6755B **County Permit Review Worksheet** 1372

IMPROVEMENT PERMIT for a RESIDENTIAL ON-SITE WASTEWATER TREATMENT & DISPOSAL SYSTEM

RE: Request for an Improvement Permit for Lot 17 off of Sample Road.
MCHD File #6755B

SEPTIC SYSTEM DESIGN REVIEW WORKSHEET

Sketch of Soil Evaluation Locations

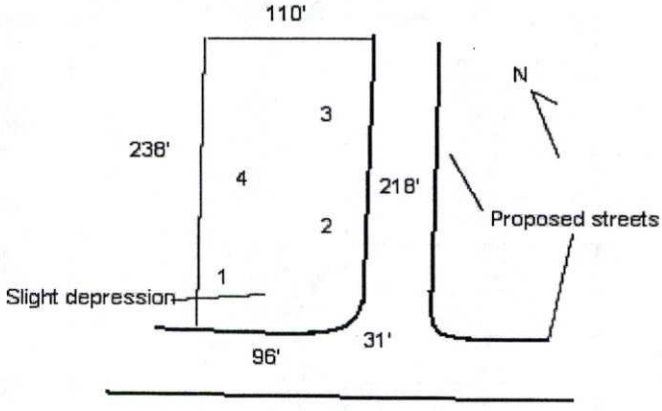
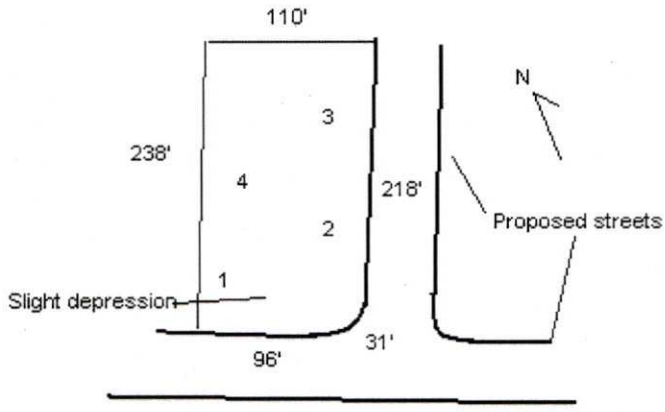
1. Need updated application on file for 5 bedrooms.
2. Update soil report to reflect 5 bedroom evaluation.

Owner: Faison- Sample Road LLC
Applicant: S & ME- Toney Jacobs
Address: 121 W. Trade St., 27th Floor, Charlotte, N. C. 28202-5399
Date Evaluated: 2/22/07
Proposed Facility: Residence
Design Flow (.1949): 600 gpd
Property Size: .63a
Location of Site: Off Sample Road
Property Recorded:
Water Supply: [x] Public [ ] Individual [ ] Well [ ] Spring [ ] Other
Evaluation Method: [x] Auger Boring [ ] Pit [ ] Cut
Type of Wastewater: [x] Sewage [ ] Industrial Process [ ] Mixed
